OIL INDIA LIMITED
(A Government of India Enterprise)
P.O. Duliajan – 786602, Assam, India
Website: www.oil-india.com

Corrigendum No. 5 to IFB No. CPG2023P20

**Engineering, Fabrication and Construction, Testing and Commissioning
of Modular Field Gas Gathering Station at Baghjan, Assam**

OIL's/ EPMC's response to Bidder's queries to various sections of Tender documents.

POWER MOTOR CONTROL CENTER (PMCC-6001)
415V SWITCHGEAR
LOCATION : SUBSTATION ROOM
PHASE-I

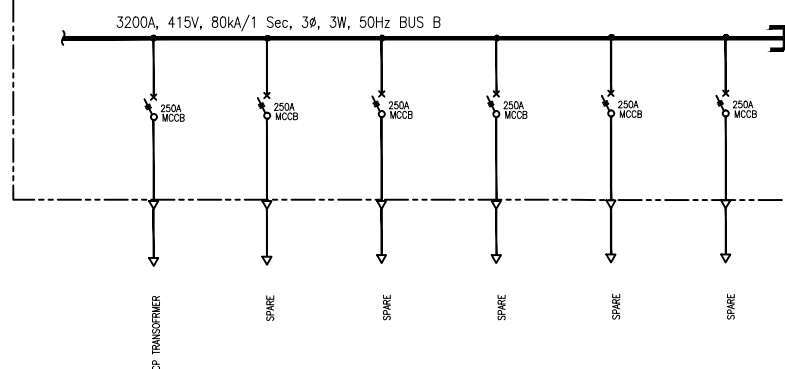
10	CORRIGENDUM No. 01, IFB No. CPG2023 P20 / ELECTRICAL DESIGN BASIS, Page No. 31 of 44 (1289 of 2248)	BUS DUCT	BUS DUCT “ <u>Consultant/ OIL's Response:</u> There is no separate datasheet/ specification has been prepared and for basic details refer clause 11.10 in electrical design basis. This shall be as per international codes and standards.	As per Client's clarification (S. No. 101), Bus Duct type mentioned in Electrical design Basis (FGGS-BJN-ELC-DBM-6000) (Clause No. 11.10) is “ Non-phase segregated , self-cooled type, sandwiched type” but Bus Duct type mentioned in SLD (FGGS-BJN-ELC-DIA-6000 -02/06) is “ Sandwich type ”. Kindly clarify which type required.	Please refer Annexure-B of Attachment-II of this Corrigendum.
11	Technical Tender_Final-9, Page No.1550/ 2248	SLD Bus Coupler Rating		Kindly note that, in worst condition also bus coupler will only see only Gas Generator Full Load Current (i.e. Approx. 2500A). Hence, bidder recommends considering Bus Coupler current rating as 3200A matching with incomer breaker. Request to kindly confirm our understanding.	Bus coupler current rating shall be equal to the incomer. Bidder shall follow the updated SLD attached as Annexure-B of Attachment-II of this Corrigendum.

12	Technical Tender_Final-9, Page No.1555/ 2248	SLD Bus Coupler Rating		Kindly note that, in worst condition also bus coupler will only see only 800A current (Incomer breaker rating). Hence, bidder recommend considering Bus Coupler current rating as 630A (80% of Incomer breaker rating) as standard practice. Request to kindly confirm our understanding.	Bus coupler current rating shall be equal to the incomer. Bidder shall follow the updated SLD attached as Annexure-B of Attachment-II of this Corrigendum.

64	Vol-II, Technical	Single Line Diagram Page no.1550 of 2248	SLD	Modification	Please refer Attachment-II of Corrigendum No. 5.	
65	General				The above-mentioned changes shall be applicable to all specification and datasheet which is part of the tender. The above changes supersede the tender documents.	
66	General		List of approved manufacturers of the critical electrical components/ items.	Addition	Please refer Attachment-I of Corrigendum No. 5.	
67		1512 of 2248	Data sheet Sl. No. 17	Modification	1875 kVA at 0.8 pf	Minimum 1875 kVA at 0.8 pf with higher rating up to 10% acceptable.
68		1518 of 2248	Data sheet Sl. No. 5.0	Modification	750KVA at 0.8 pf	Minimum 750KVA at 0.8 pf with higher rating up to 10% acceptable.
69	Volume-I, Commercial	BEC/BRC		Modification		Modified BEC/BRC is attached as Attachment-III
70	Volume-I, Commercial	SOR/P		Modification		Modified SOR/P is attached as Attachment-IV
